Site Plan

Westport Business Park Lot 5

May 28, 2026

A. Executive Summary and Request:

1 SITE PHOTOMETRIC PLAN
 SCALE: 1" = 20'-0"
 0 10' 20' 40'

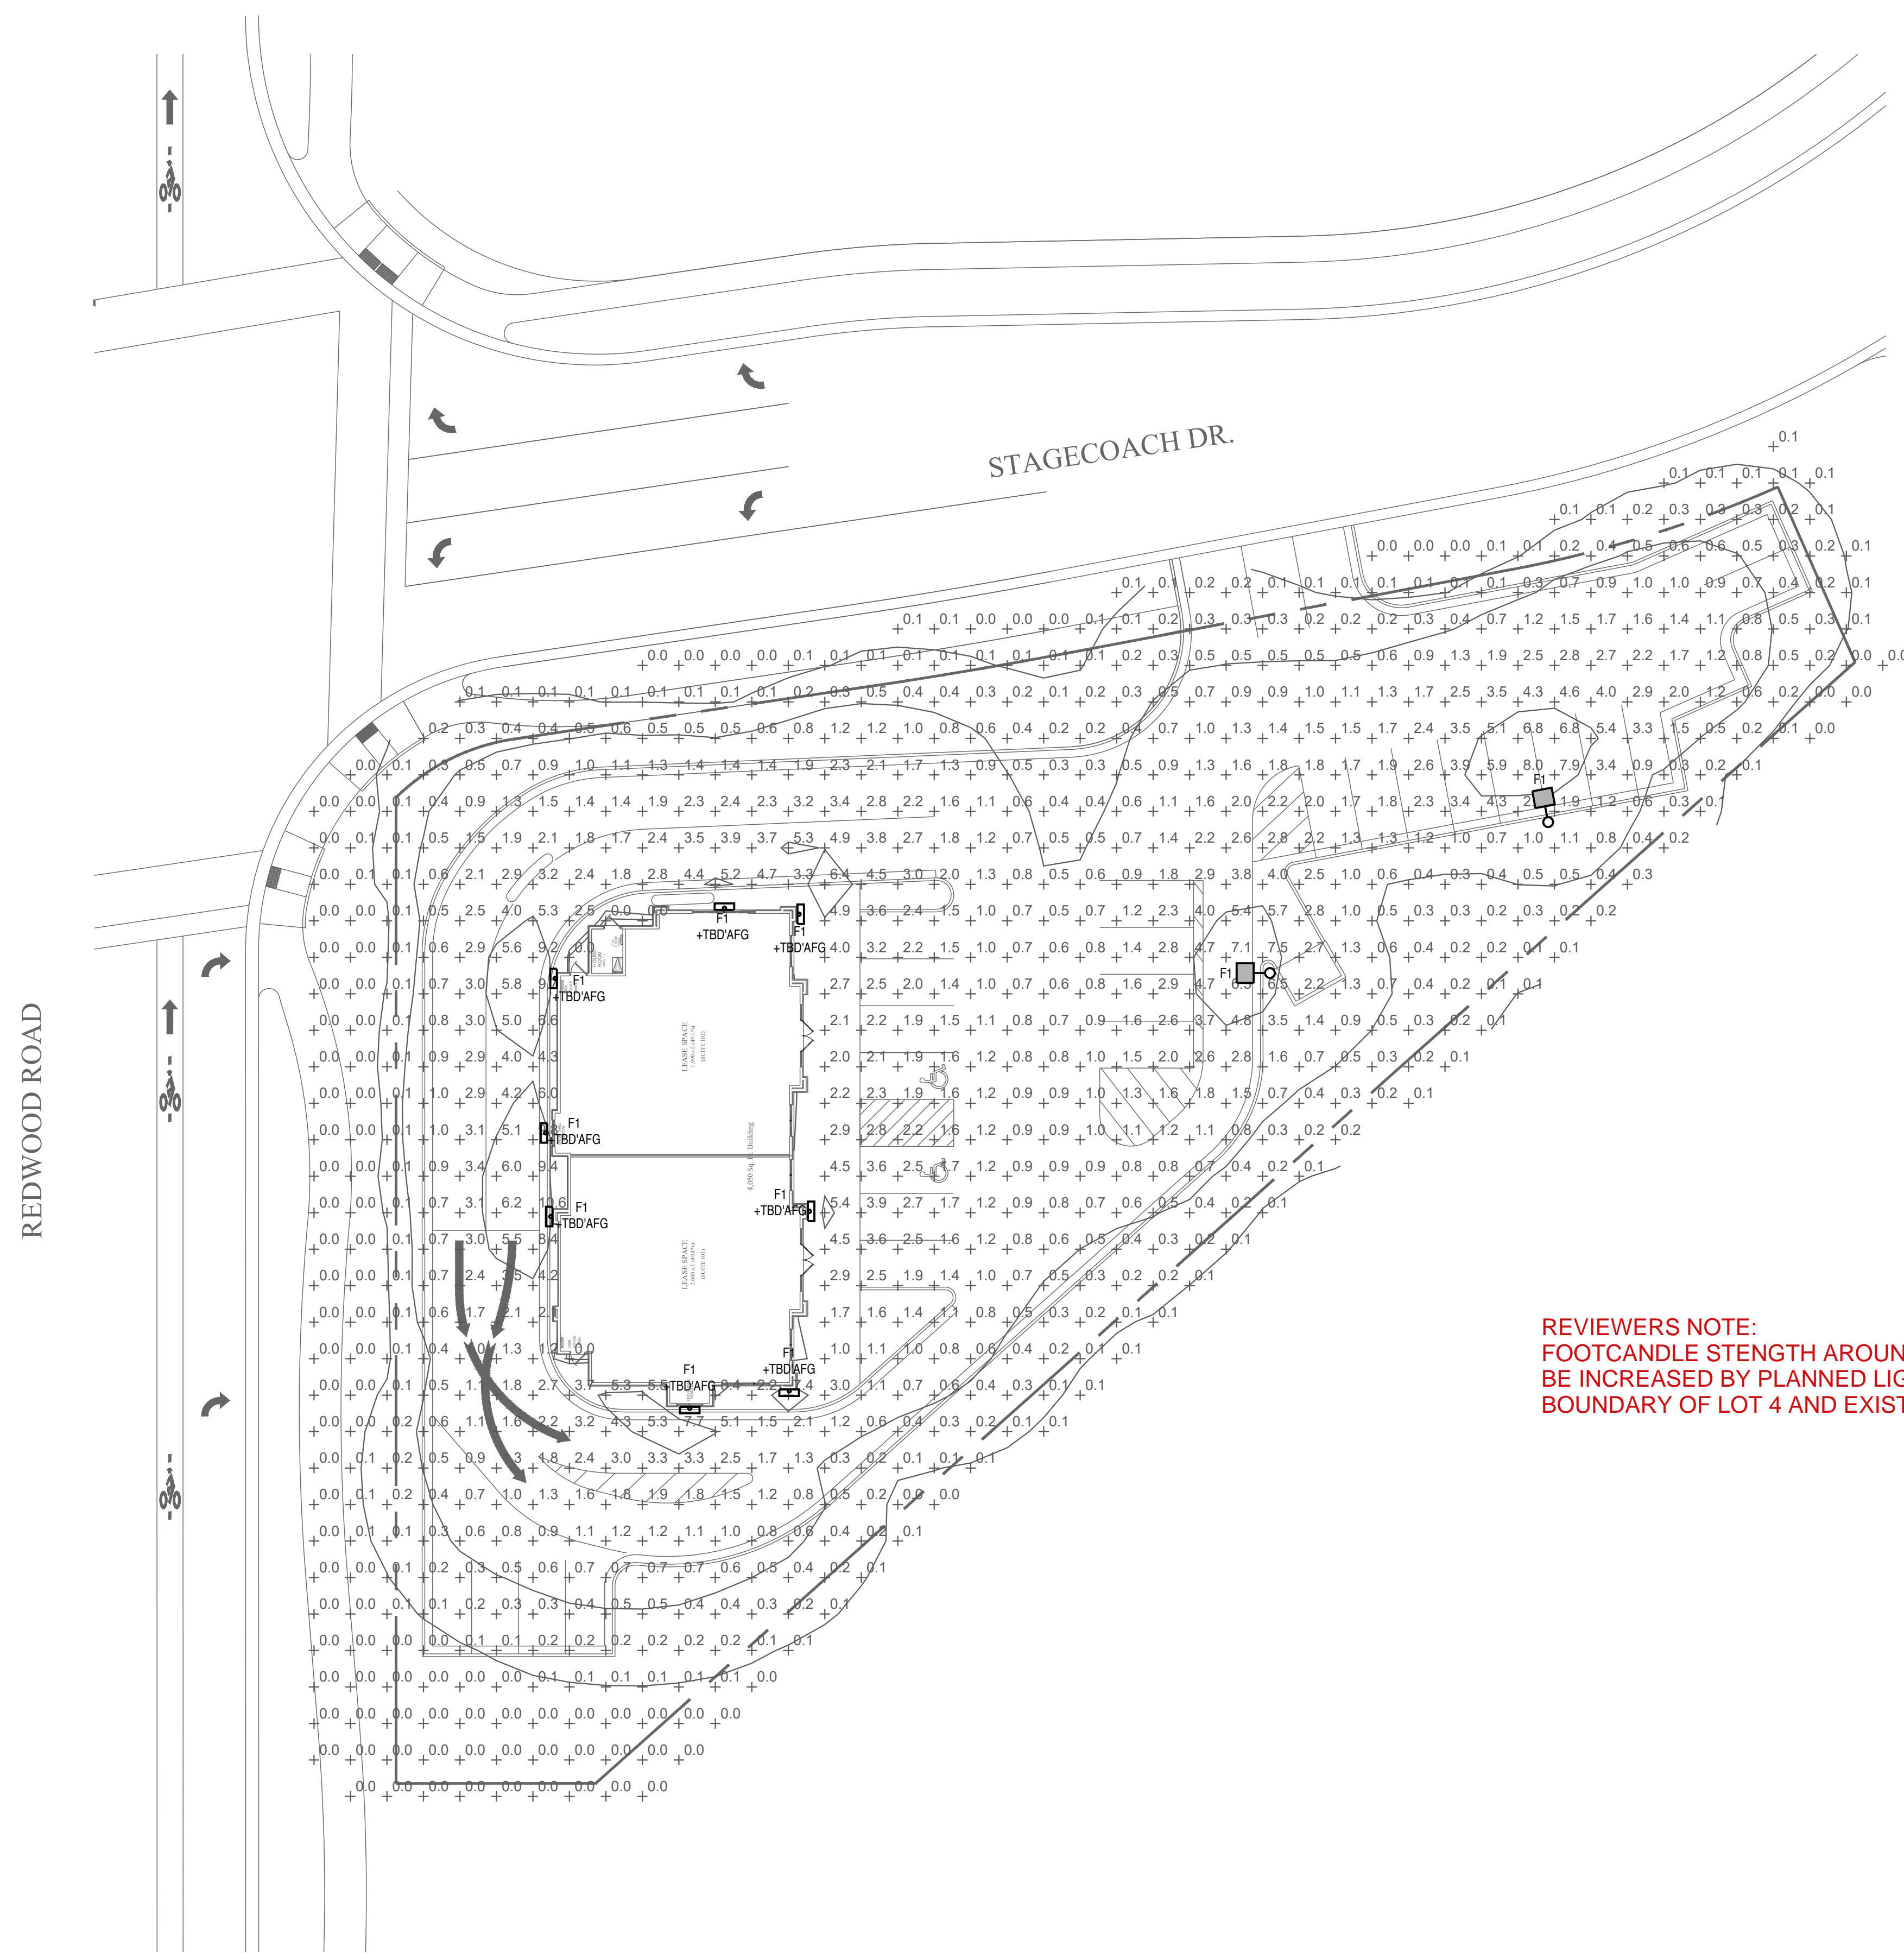
REVIEWERS NOTE:
 FOOTCANDLE STRENGTH AROUND THIS LOTS PERIMETER WILL BE INCREASED BY PLANNED LIGHTING ALONG THE ADJACENT BOUNDARY OF LOT 4 AND EXISTING STREET LIGHTS.
